CONNECTICUT SITING COUNCIL

RE: **DOCKET NO. 466** - The Connecticut Light & Power Company d/b/a Eversource Energy Certificate of Environmental Compatibility and Public Need for the Frost Bridge to Campville 115-kilovolt (kV) electric transmission line project that traverses the municipalities of Watertown, Thomaston, Litchfield, and Harwinton, which consists of (a) construction, maintenance and operation of a new 115-kV overhead electric transmission line entirely within existing Eversource right-of-way and associated facilities extending approximately 10.4 miles between Eversource's existing Frost Bridge Substation in the Town of Watertown and existing Campville Substation in the Town of Harwinton; (b) related modifications to Frost Bridge Substation and Campville Substation; and (c) reconfiguration of a 0.4 mile segment of two existing 115-kV electric transmission lines across the Naugatuck River in the Towns of Litchfield and Harwinton within the same existing right-of-way as the new 115-kV electric transmission line.

RE: Docket No. 466: Frost Bridge to Campville 115-kV Project
Development & Management Plan Change Notice Request:
Proposed Access Road Shift: Town of Thomaston

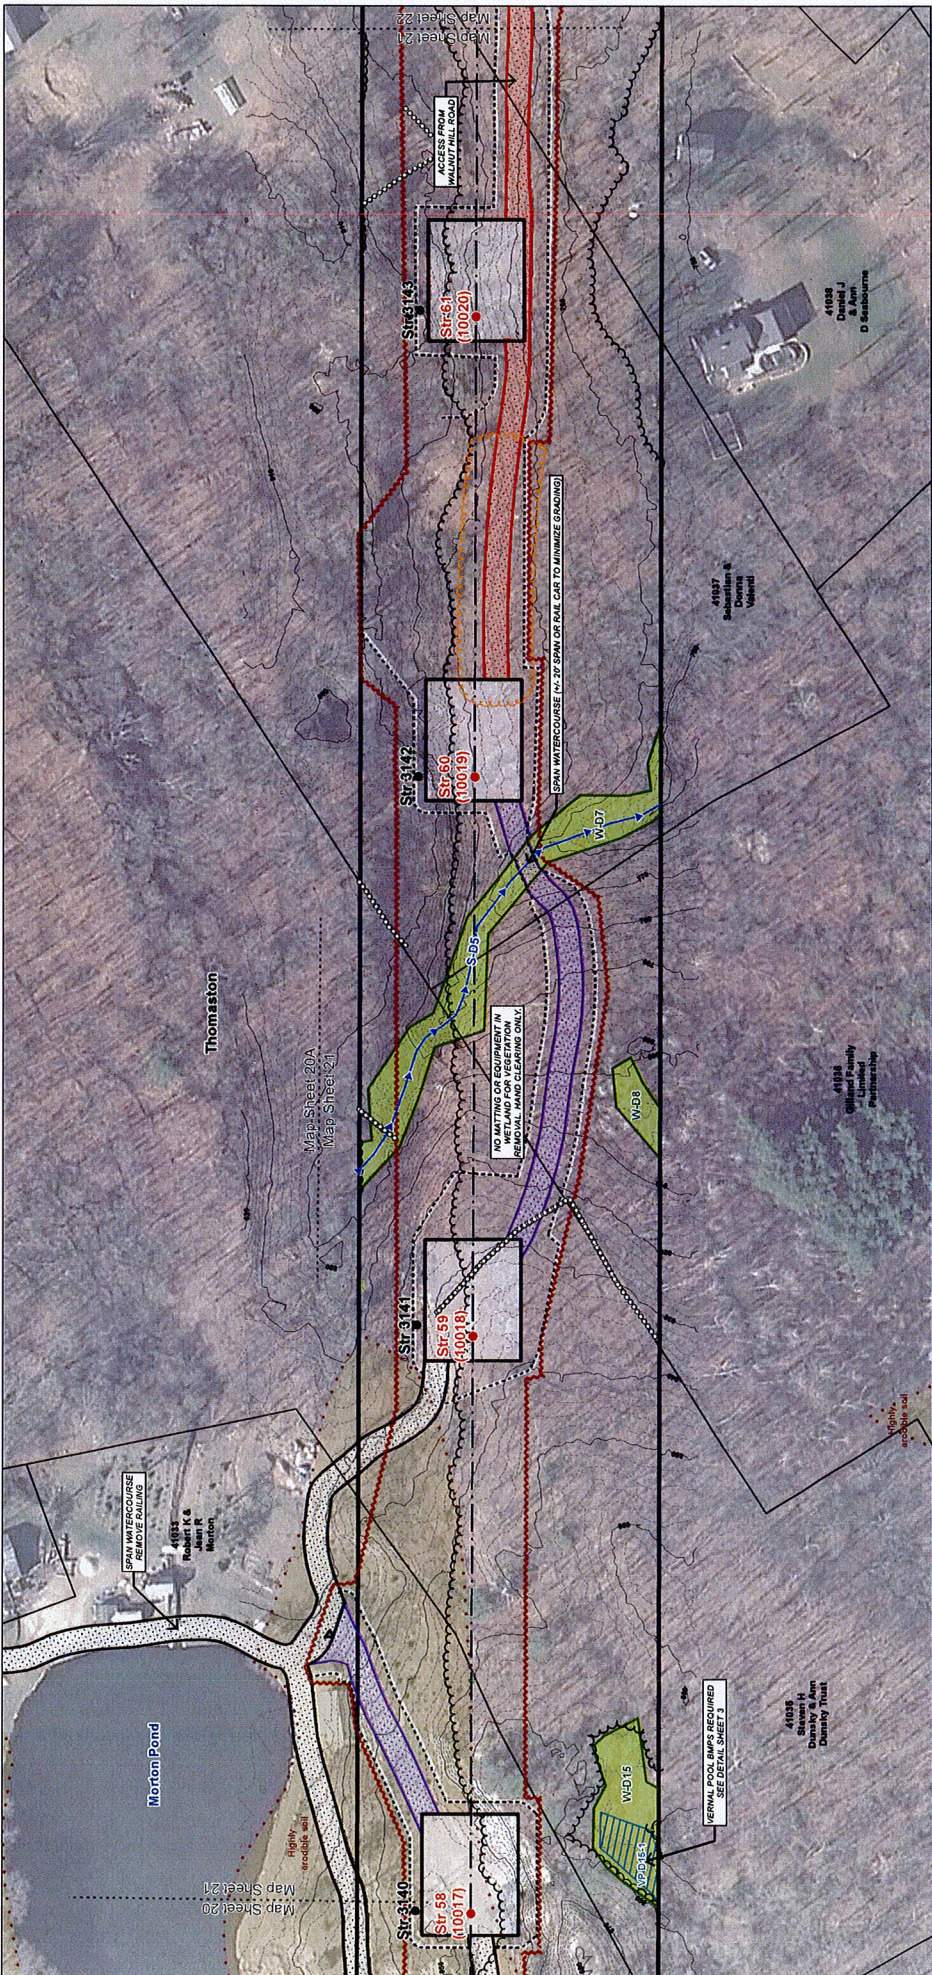
Shift the location of the access road between Structures 60 and 61 located southeast of Walnut Hill Road within the Town of Thomaston. Presently, existing access between these two structures uses an off right-of-way road that has steep grades, creating difficulty for construction vehicles. Eversource would shift access to these structures by establishing a new access road within the right-of-way between the two structures. The new access road would be in an upland area and has a moderate grade. The new access road would decrease the distance between the structures by 100 feet and improve stormwater management by avoiding steep terrain.

The proposed change involves a shift in the location of a portion of the access road between Structures 60 and 61 (Line List 41037, D&M Plan Mapsheet 21). As currently planned, the access between these two structures includes part of an existing access road that extends off the ROW (which would have to be improved) and portions of new access roads that would extend it to Structures 60 and 61. The connection of the off-ROW access into Structure 60 would traverse steep terrain.

To avoid this steep terrain, Eversource proposes to eliminate the use of the off-ROW portion of the existing access road and instead construct the access road between structures 60 and 61 entirely within an upland area within the ROW, as illustrated on the attached D&M Plan Mapsheet 21 (Revision 2). The proposed access road shift would decrease the length of the road between Structures 60 and 61 by approximately 100 feet and facilitate stormwater management during construction by avoiding steep terrain. The property owner (Line List 41037) has been notified of the proposed access road shift.

Pursuant to Regulations of Connecticut State Agencies §16-50j-62(b), your request for the revision submitted on April 12, 2017 is hereby approved. This approval applies only to the D&M Plan revision dated April 12, 2017. Any significant changes to the D&M Plan require advance Council notification and approval.
